DESCRIPTION OF PROPOSED CHANGE NDF-10-51 AND SAFETY ANALYSIS
AMENDMENT APPLICATION NO.15 , OPERATING LICENSE NPF-10

This is a request to make various editorial changes in Appendix A, Technical Specifications.

Figure 3.4-2

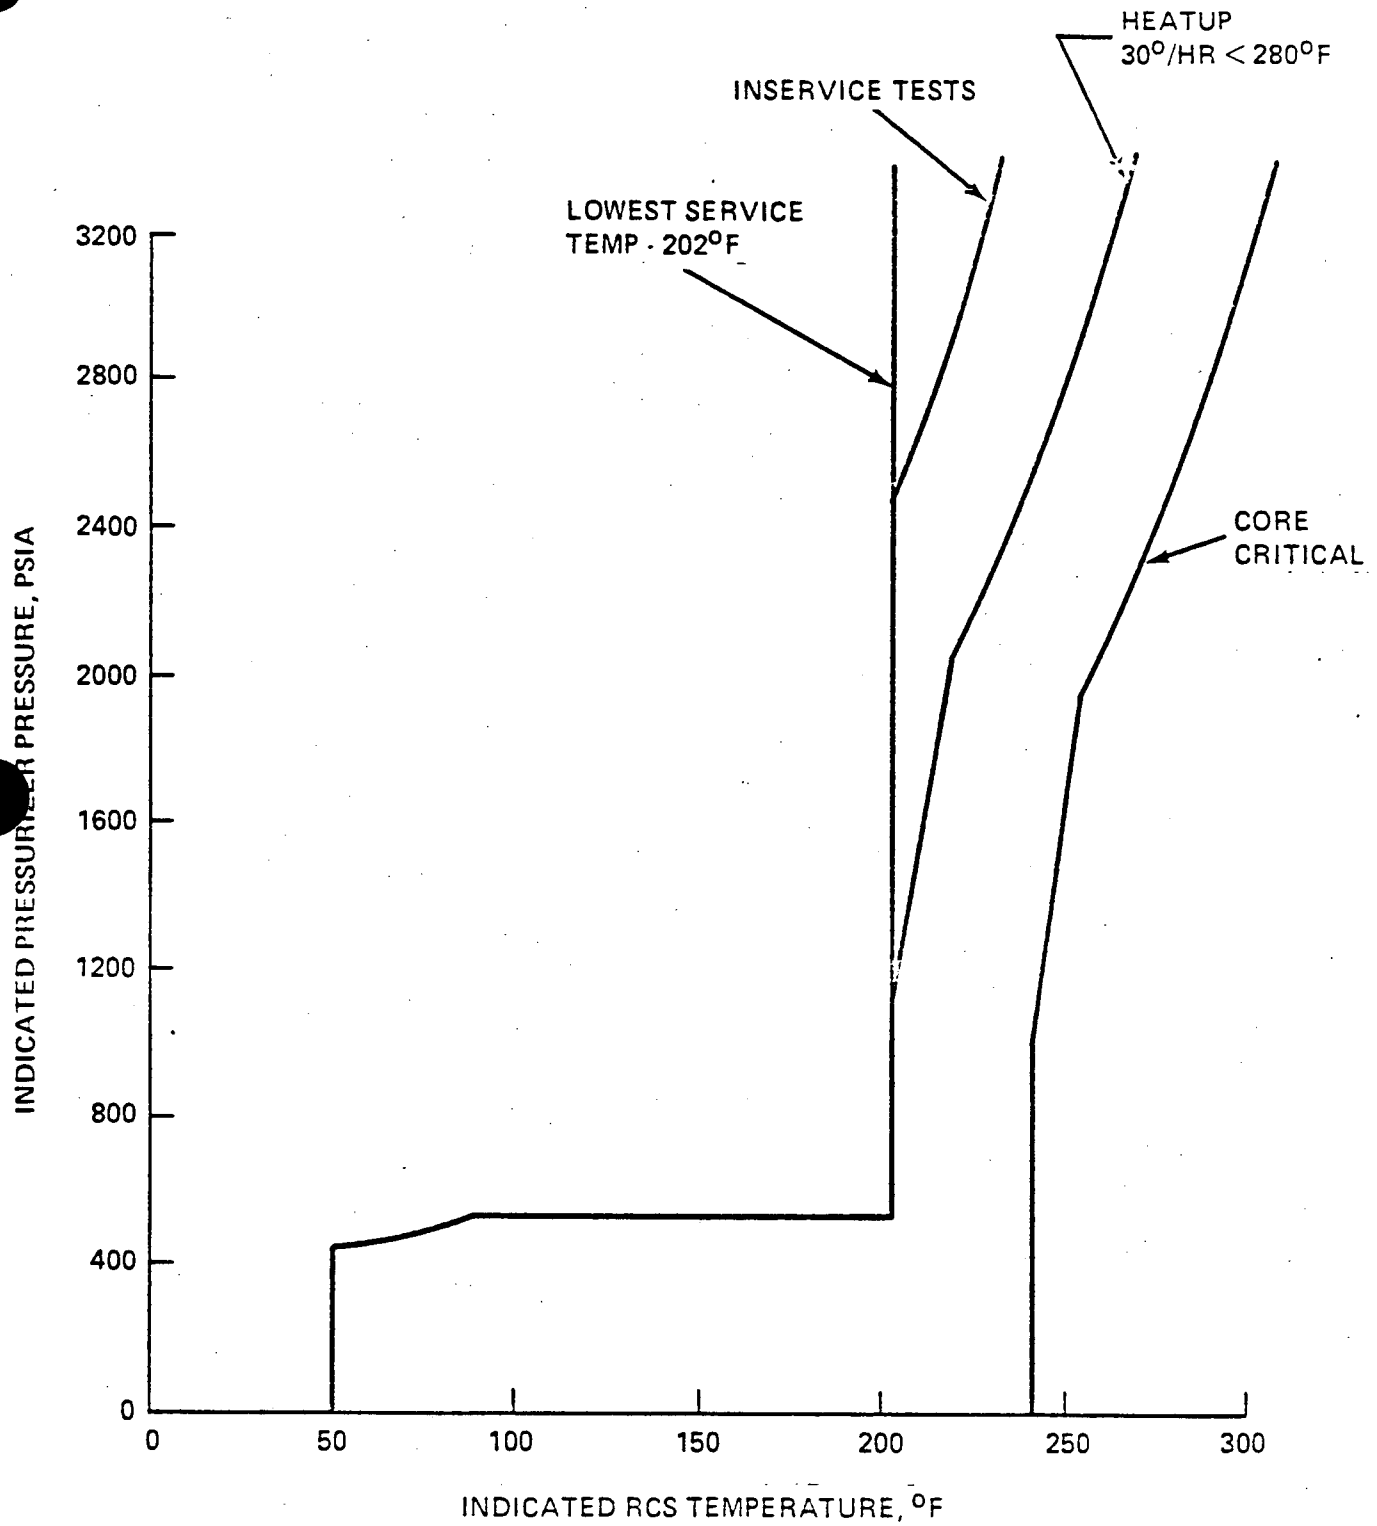
3/5 4.29 Change title of Figure 3.4-2 to all CAPS and delete ": SCE 11" from title.

Figure 3.4-3

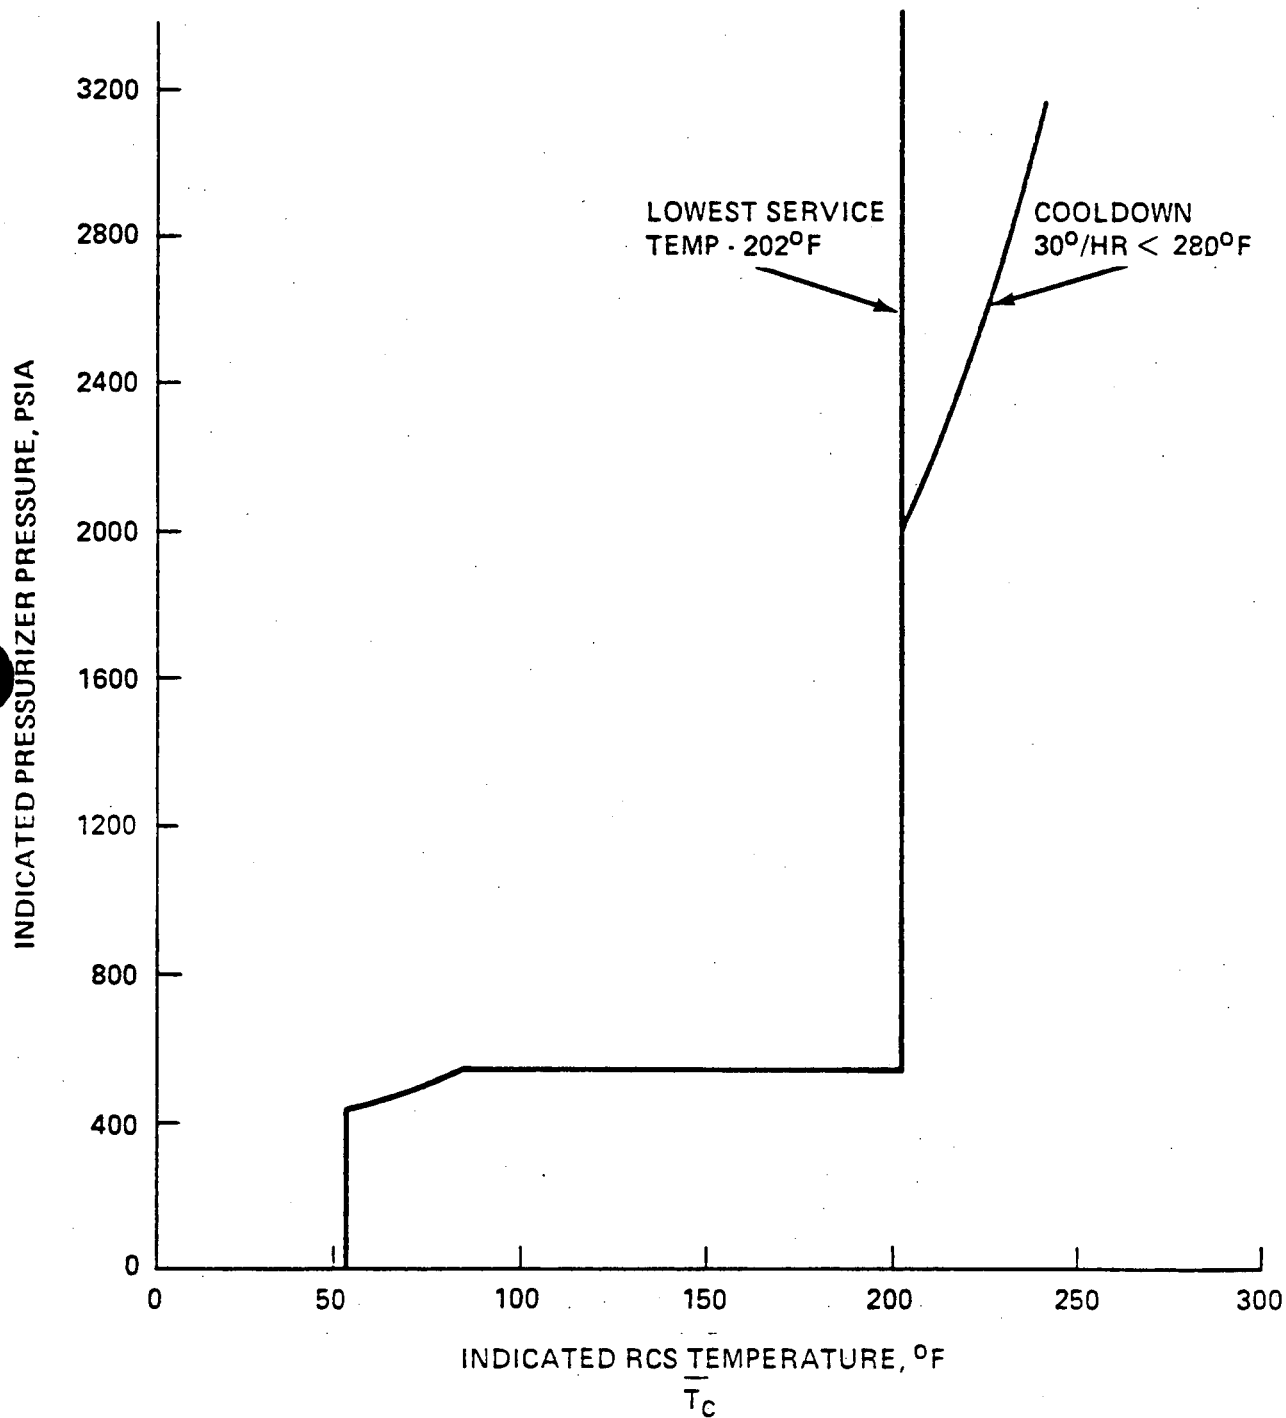
3/4 4-30 Change title of Figure 3.4-3 to all CAPS and delete ": SCE 11" from title,
